DART SERVICE INSTRUCTION TO AMEND INSTALLATION INSTRUCTIONS IIN-D505-1057 REV. B,

INSTALLATION INSTRUCTIONS II505-1 REV. E. INSTRUCTIONS FOR CONTINUED AIRWORTHINESS ICA-D505-1057 REV. 1, AND INSTRUCTIONS FOR CONTINUED AIRWORTHINESS ICA505-1 REV. 3 OR LATER APPROVED REVISIONS

2.0 CHANGE: RELOCATION OF LOOP CLAMP AND L-BRACKETS

DRAWN SAD HAWKESBURY, ONTARIO, CANADA PPROVED DRAWING NO. CHECKED HE DSI 9865 MFG. APPR. N/A SHEET 1 OF 4 TITLE **APPROVED** CP 505 FLOAT ATTACHMENT DE APPR. CP U

FIGURE 2

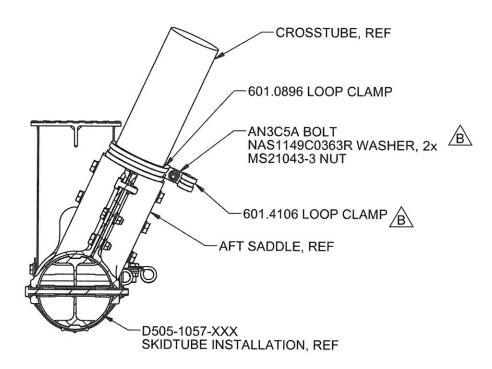
3.0 CHANGE: L-BRACKET REPLACEMENT ON AFT SADDLE

The 601-0733 L-Bracket (F/N 51) shown in Figure 31 of II505-1 will not install on the aft saddle of DART D505-1057-XXX Skidtube Installations. Alternately, install an additional 601.0896 Loop Clamp (F/N 24) at the location shown in Figure 2 of this DSI. Install the 601.4106 Loop Clamp (F/N 25) and associated hardware similar to Section P-P of Figure 30 of II505-1.
